IN THE UNITED STATES PATENT AND TRADEMARK OFFICE
BEFORE THE BOARD OF PATENT APPEALS AND INTERFERENCES

In re Application of:	Art Unit: 3744
Lennart OLSSON	Examiner: W. TAPOLCAI
Appln. No.: 09/236,343	Washington, D.C.
Filed: January 25, 1999	January 29, 2001
For: APPARATUS FOR FREEZING

REPLY BRIEF

BRIEF ON BEHALF OF APPELLANT

Sheet 1

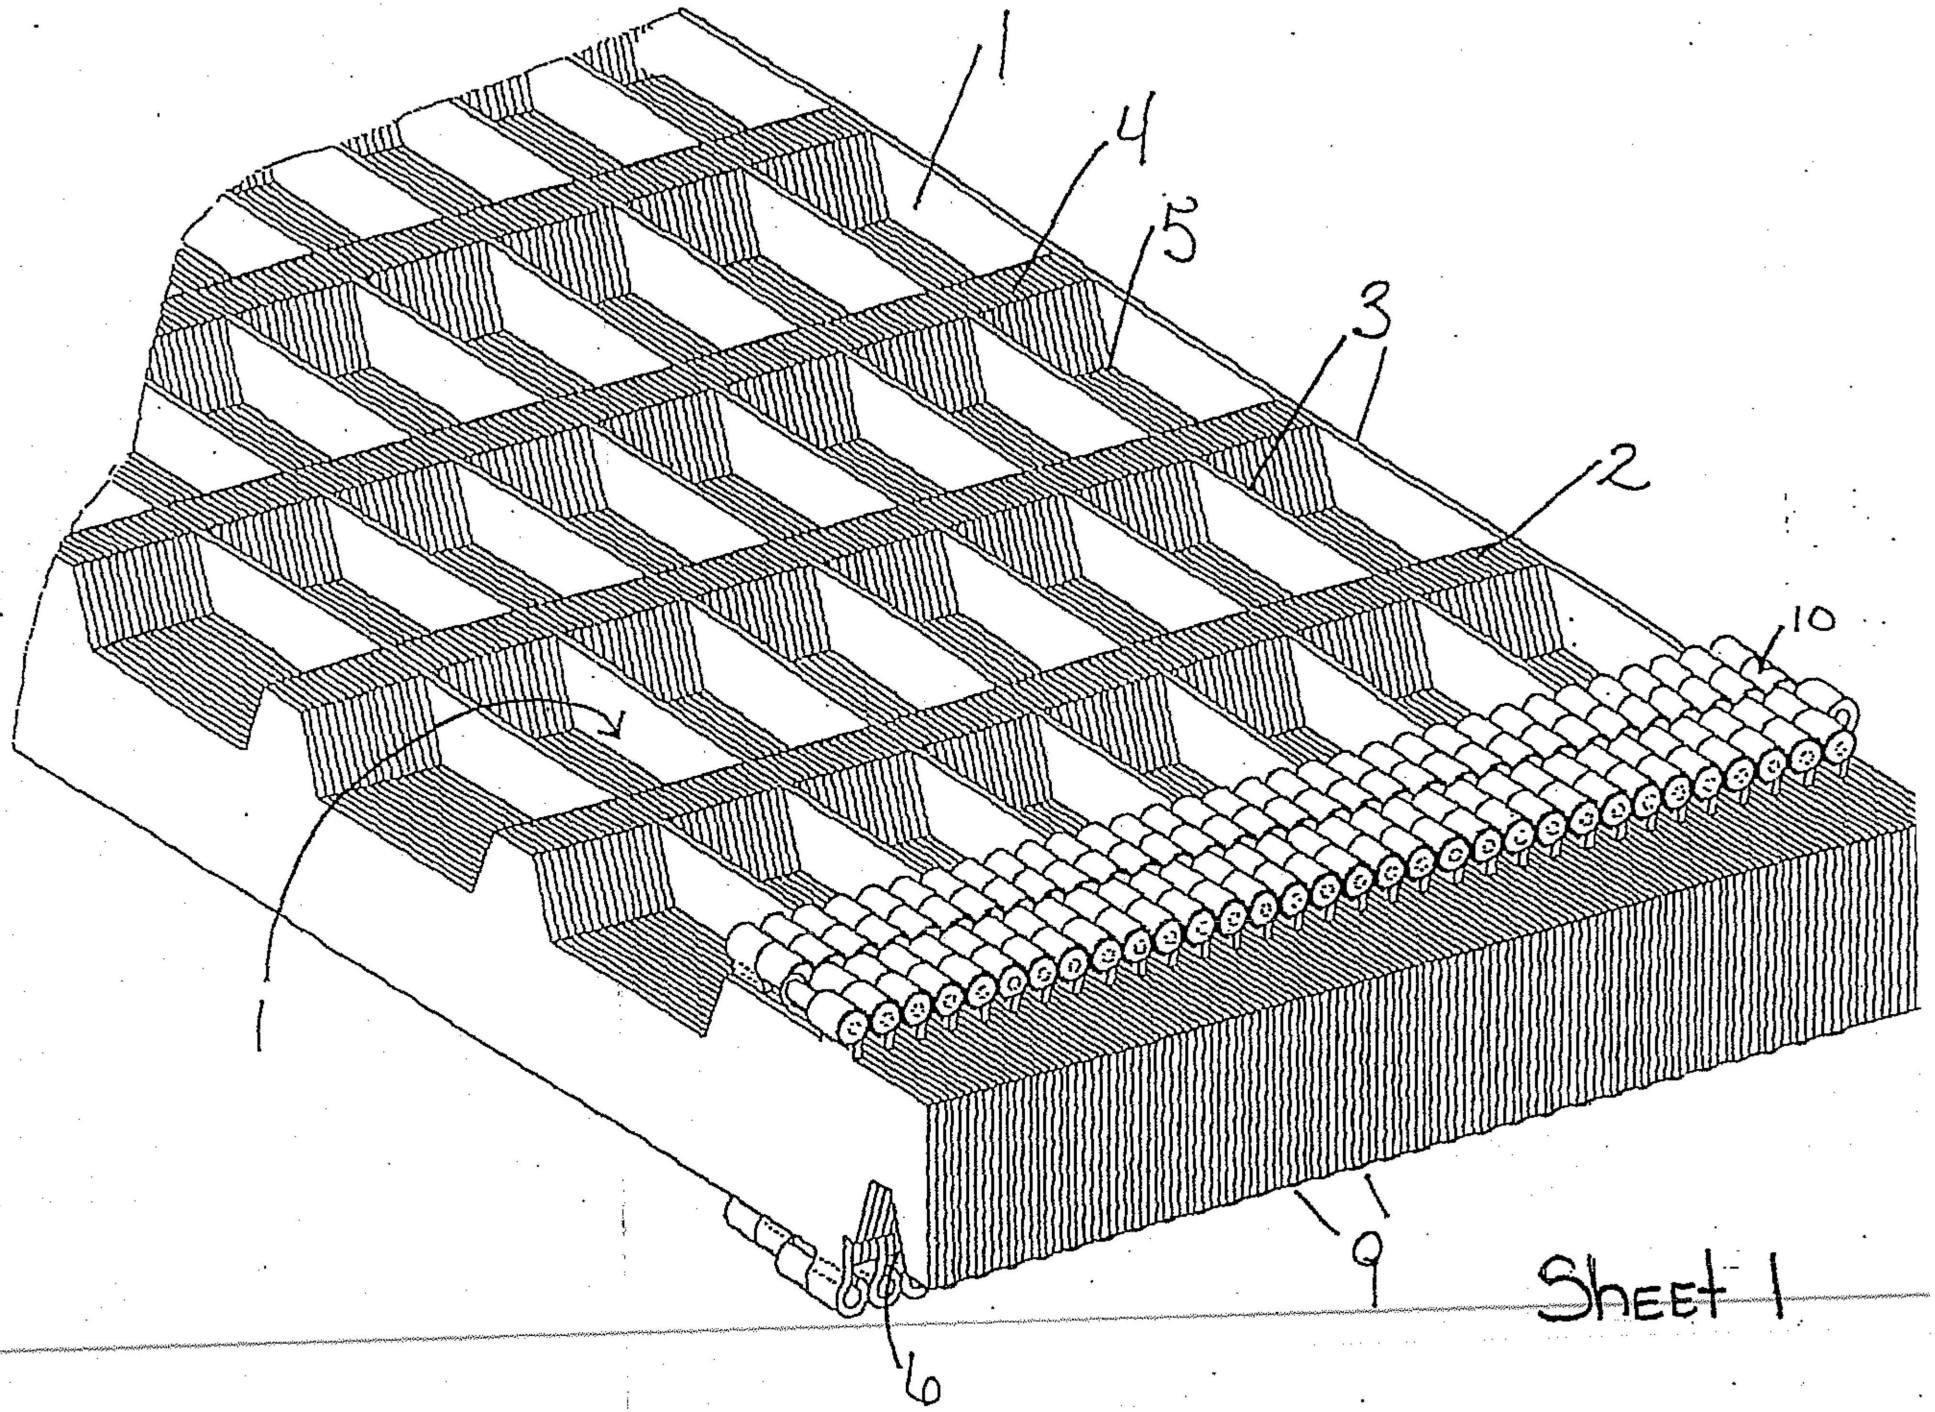
> The specification is non-enabling with respect to how the individual tray 1 is incorporated into the belt conveyor 7 of Fig. 2. In particular, it is not clear that the individual plate elements 2 and 3 of the tray 1 are hinged together so that they can fold together and apart. It is not clear from the disclosure as

originally filed that the elements 2 and 3 correspond to the elements 9 that make up the conveyor belt 7, 8 of Fig. 2. The tray 1 as shown in Fig. 1 appears to depict a tray composed of individual plate elements 2 and 3 that are permanently bonded together to form a tray with pockets that hold food elements to be frozen. There is no clear disclosure from either the specification or drawings that the plate elements 2 and 3 are to be folded together and apart like an accordion."

Attached Sheet 1 shows an enlarged perspective view of a portion of the conveyor belt 8 of Figs. 2 and 3 along path

A showing the trays assembled by push rod 13 according to the invention.

As made clear from Fig. 1, and attached sheets 1 and 2, elements 9 (comprising elements 2 and 3 in the order shown) make contact with each other with the assistance of push rod 13 to form horizontal and assembled trays 1 having a surface area 4 on the upper side of each assembled tray 1 and downwardly directed recesses 6 so that elements 2 and 3 (forming trays) can be supported and moved along two parallel rails (see page 4, lines 24-28 and sheet 4) extending transversely to the longitudinal direction of the trays. Thus, as indicated each assembled tray 1 is continuous and unbroken, such that the cavities 5 can hold a liquid food product that has been poured into them (while moving in path A) for freezing.
